Department of Veterans Affairs
Office of Construction & Facilities Management
Washington, DC 20001

LA National Cemetery Columbarium Expansion
Solicitation Number: VA101-17-R-0319

Answer to RFI Question's

Drawing Number A4, Key Notes 1 and 2:

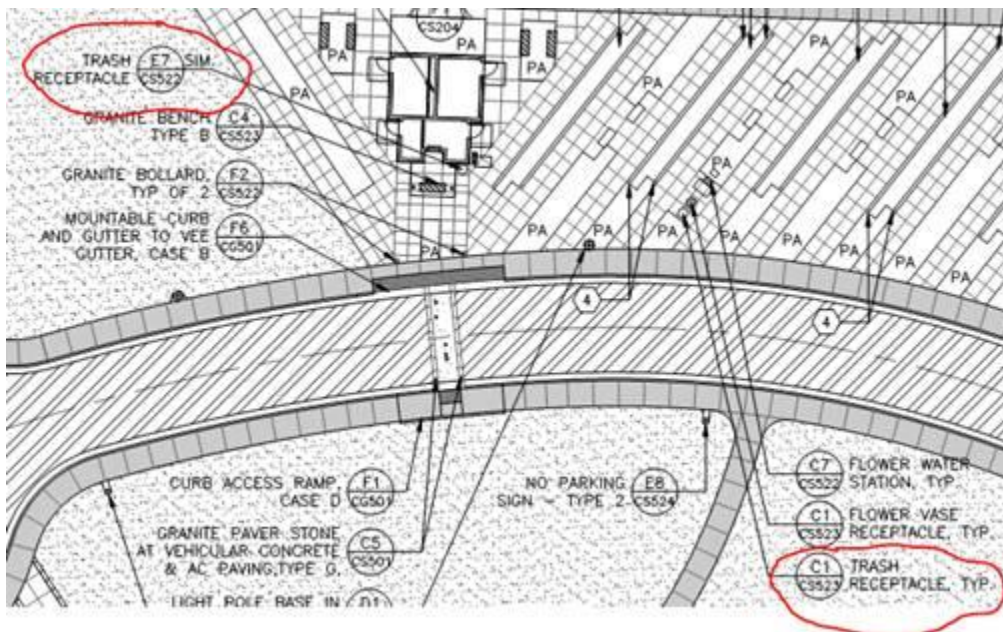
Q4: Committal Shelter

Assuming these items are covered under section '04 72 00 Cast Stone Masonry', please clarify.

VA RESPONSE: CONFIRMED THIS IS COVERED IN THIS SECTION
